**Development of Bristol Airport to Accommodate 12 Million Passengers Per
Annum: Response to Comments from North Somerset Council on Biodiversity**

This note has been prepared in response to comments provided by the North Somerset Council (NSC) Biodiversity Officer on the planning application and supporting Environmental Statement (ES) for the proposed development of Bristol Airport to accommodate 12 million passengers per annum (mppa) (Application No. 18/P/5118/OUT). Specifically, the note responds to comments received in respect of the biodiversity impacts of the proposed development.

North Somerset Council: Formal Comments from Sarah Dale, Temporary Natural Environment Officer – 24/01/18 and by email 14/02/19	
Theme/Subheading	Extract from document and BAL response
<p>Summary: Designated Sites</p> <p><i>Please refer to detailed response below.</i></p>	<p>It has been ascertained that NOx emissions, nitrogen deposition and acidity will exceed critical loads or targets for several designated sites, but that the levels of this are not considered to be significant. I will need to seek further advice from colleagues in the air quality team and their supporting consultants regarding

Figure 1. SSSI locations for Reference

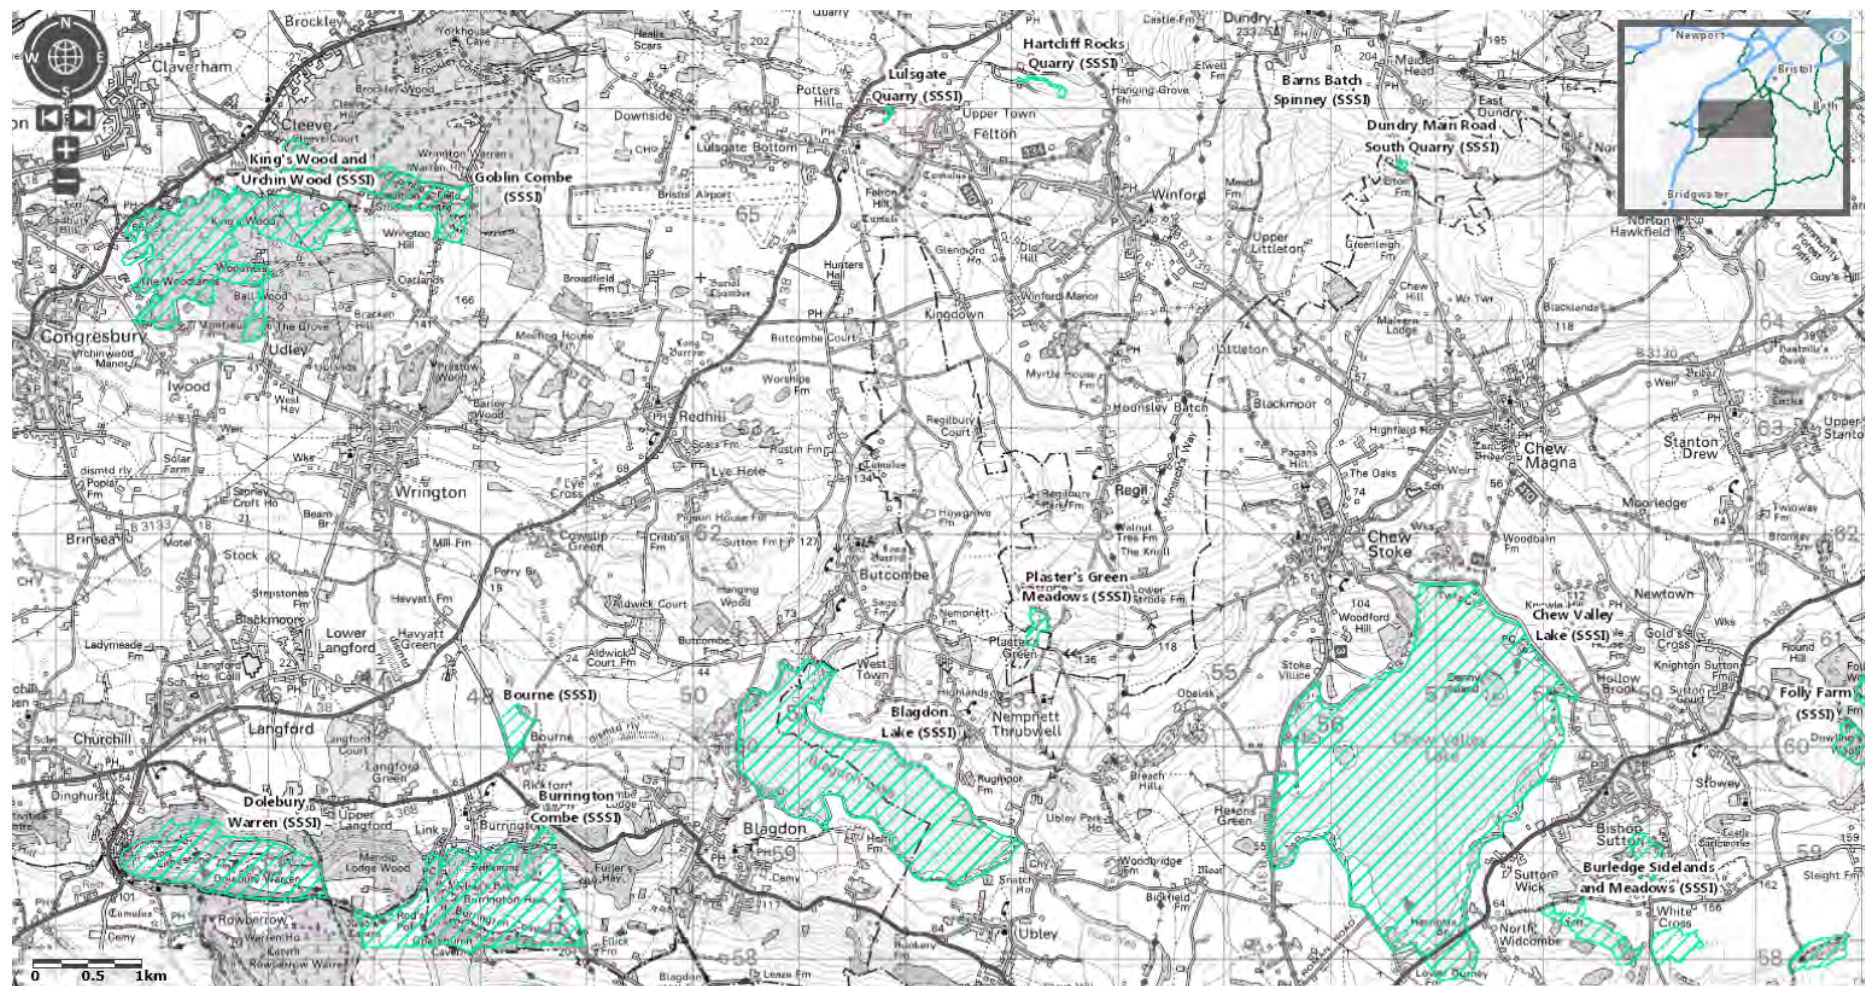
Other Designated Sites	
Further information 4	<i>"I am satisfied that impacts on wetland birds including disturbance can be scoped out of the ES. I would also not consider that a Habitats Regulations Assessment (Test of Likely Significant Effect) needs to be provided, although this is subject to agreement with Natural England"</i>
<p>Natural England has not raised this as being of further concern in its written response to North Somerset Council dated 25th January 2019 reference 268908.</p> <p>BAL has contacted Natural England (Amanda Grundy) and a site visit and meeting with Amanda Grundy, together with a bat specialist and SSSI specialist has been arranged for 04/04/19 to discuss/agree any final concerns/advice through its Discretionary Advisory Service.</p> <p>BAL has also conducted further research and review of its track keeping data and this information is provided below with respect to statutorily designated sites associated with wetland birds. This information demonstrates that no flights below 1000ft (which are those perceived to have the greatest potential to cause short term disturbance) have been recorded within the sample data (August 2017 – one of the business periods of flying). The following figures illustrate the location of key statutory designated sites associated with birds for reference against flight track data, that includes those designated/notified for bird interest (Figures 1 and 2) and flight tracks/Above Ground Level (AGL ft) for arrivals in August 2017 (Figure 3) and departures in August 2017 (Figure 4). NB SPA is used as a surrogate for the location of related Ramsar Sites)</p>
